SERIAL 008, 895

U.S. Patent Aug. 11, 1987 Sheet 6 of 6 4,685,698

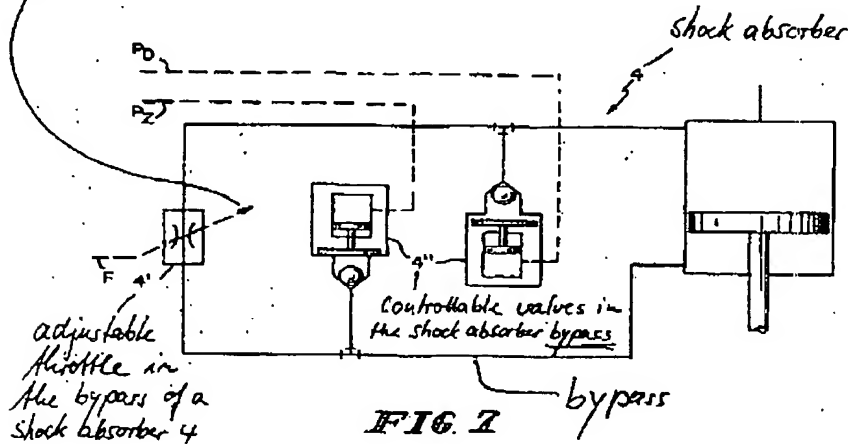
This arrow in hydraulic elements always indicates that the element is adjustable, thus also completely closeable, and not having a non-varying constricted flow cross-section!

- 1) On page 2 of the Office Action of 27.01.2005 the examiner states that 4' in Fig. 7 of Klinkner designates a fixed bypass valve with a non-varying constricted flow cross-section. In column 7, line 13 of Klinkner it is clearly stated that 4' designates an adjustable throttle 4' in the bypass of a shock absorber. Thus, it is clear that the examiner is in error.
- 2) Fig. 7 of Klinkner clearly shows an adjustable and controllable bypass of a shock absorber. There is no fixed bypass ~~with~~ having a non-varying constricted flow cross-section.
- 3) Values 4'' are located in the bypass, see Fig. 7 and column 7, line 9 ~~to~~ to line 18. In our invention, the flow regulating systems for the compression and decompression phase which provide continuous damping by having continuous flow resistance are not located in a bypass, but in the main flow path through piston 3!
